# VNI - Independent Verification and Assessment

TransGrid

27 October 2020

**Figure 3 Effective reactance capacity over operating current range<sup>15</sup>**

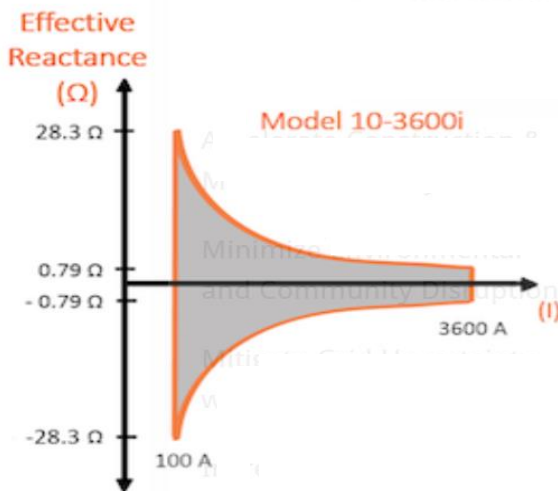
The final design of the Stockdill system (45 x i3600 units) will require a reactive voltage injection of 2830 V at an operating line current of 2570 A and under emergency operating condition, a current of 2900 A for 2 hours. The effective reactance is a function of the injected current created by the injection voltage as a proportion of the line current. The required reactance is a function of the change in relative impedance of the transmission lines on the system to balance the flows across the network and determined by system modelling.

GHD’s opinion is that TransGrid has worked effectively with Smart Wires to arrive at the optimum scope for the MPFC systems. It is evident that the design specification for SmartValves at both Stockdill and Yass went through several changes as different sizes and numbers of units which were identified in various documents at various stages of the project development.

**Figure 4 Comparative FACTS installed costs - \$A2018**

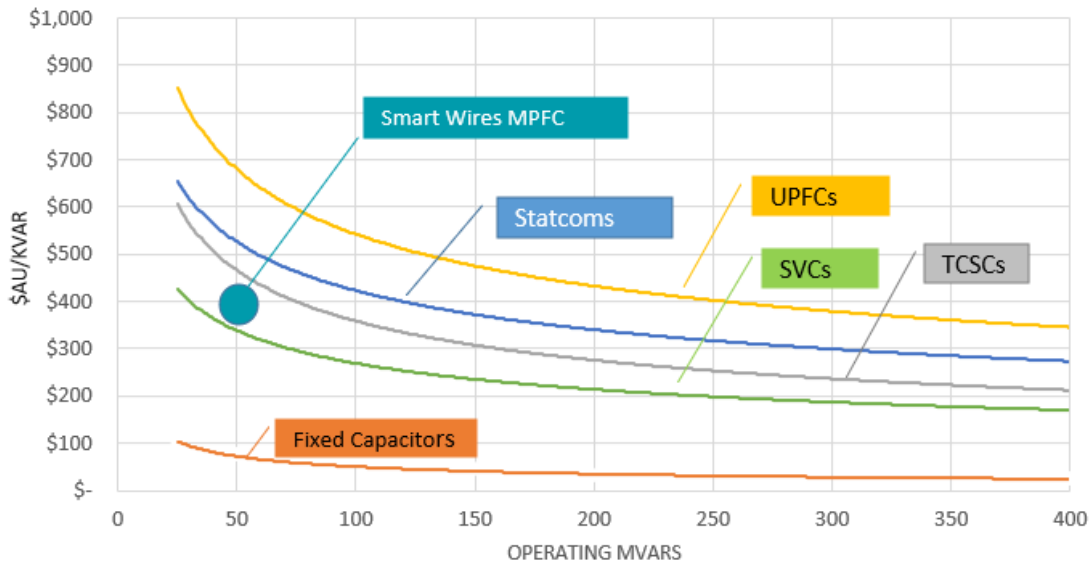
The unit pricing for the Smart Wires MPFC is less than TCSCs – a more direct competing technology solution. TCSCs use thyristors to control fixed capacitors and reactors to provide faster and more variable response compared to fixed capacitors. They require a much larger footprint compared to the MPFC solution and the system components are required to be insulated to the system voltage (330kV in this case), all contributing to much larger costs overall for manufacture, supply and installation.

Statcoms and the Smart Wires systems both use voltage source inverter technology. Statcoms provide shunt reactance and are insulated to the system voltage (330kV) and connected to the phases through power transformers to supply the rated MVar capacity. This technology is continuing to develop as the market grows. The Smart Wires system is placed in series with the conductor and the patented single core modular transformers are able to supply multiple low-power invertors and to also inject reactive voltage back into the power line conductor. The modular design also facilitates manufacturing and installation efficiencies.

The unit cost for the Smart Wire MPFC appears to be less than that for STATCOM unit costs. This may suggest that the costs are currently below sustainable business costs, however the pricing may be currently positioned to obtain market entry to compete with alternate transmission line reconductoring solutions. Smart Wares has stated the aim to achieve unit costs of \$US100/kVar in the future. GHD’s view that sustainable installed costs of between \$A300 and \$A400 per kVar will provide a cost effective alternative to upgrading transmission lines in Australia in the future.

**Figure 5 TransGrid capex overheads - reported margin <sup>23</sup>**

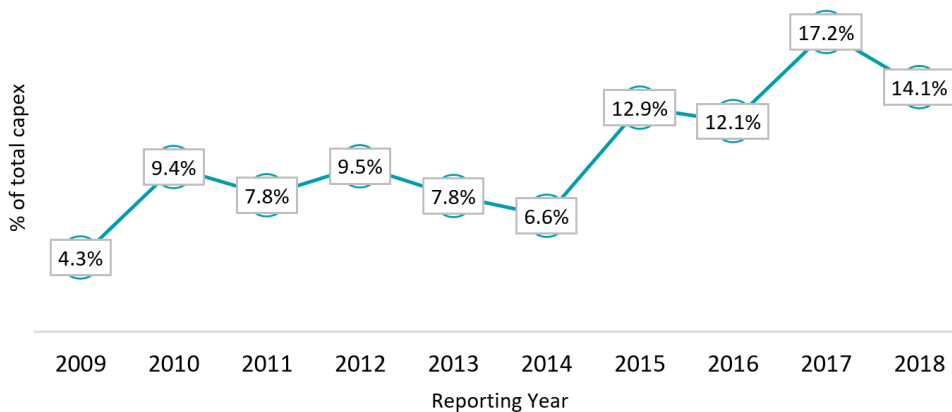
TransGrid reports annually on its actual overheads allocated with capex to AER through RINs. The reported data shows that following FY14 the level of allocated costs increased to percentage margins like those in the comparative reports<sup>22</sup>. The total capex program for TransGrid include a range capital works with differing complexity, scale and type (replacement, growth, brownfield, greenfield).

<sup>22</sup> GHD is not aware of the reason for the apparent increase in FY15

**Figure 7 Cost difference of changes from the PACR to the CPA forecast (\$M, Real \$2018<sup>26</sup>)**

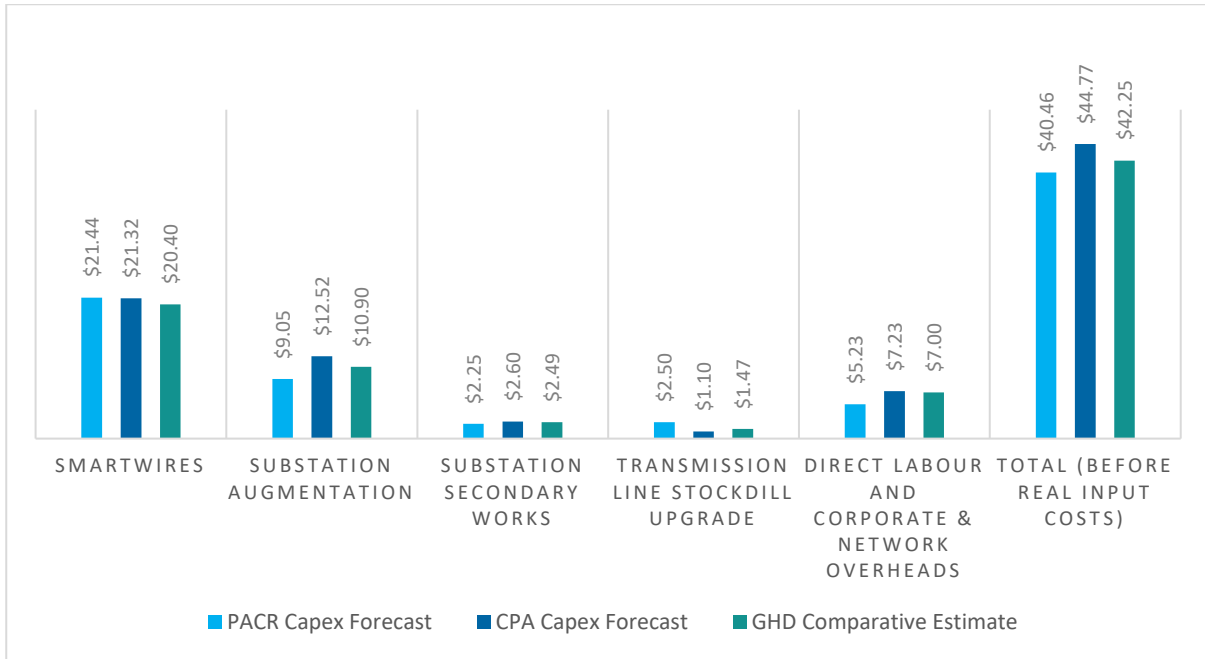
GHD has provided the comparisons of changes in costs by cost categories in Table 26 below and diagrammatically in Figure 7. Our analysis of the \$4.5 million increase between the PACR and final capex supports the analysis reported by TransGrid except that GHD considered that adjustments to the CPA forecast breakdown was warranted as follows:

- Substations – GHD identified in section 5.5 that a relocation of contractor overheads such as mobilisation, plant and project management costs provides a different total costs for substation

- Transmission lines – GHD's relocation of contractor overheads increased the costs identified by TransGrid's of \$0.4 million to \$1.1 million. The difference to the PACR would then be a decrease of \$1.4 million which is less than the \$2.1 million identified by TransGrid.
- Secondary Systems – The change of 0.4 million identified by TransGrid is unchanged after the reallocation of overheads by GHD
- Direct labour and indirect costs – GHD found the same change of \$2.1 million as identified by TransGrid.
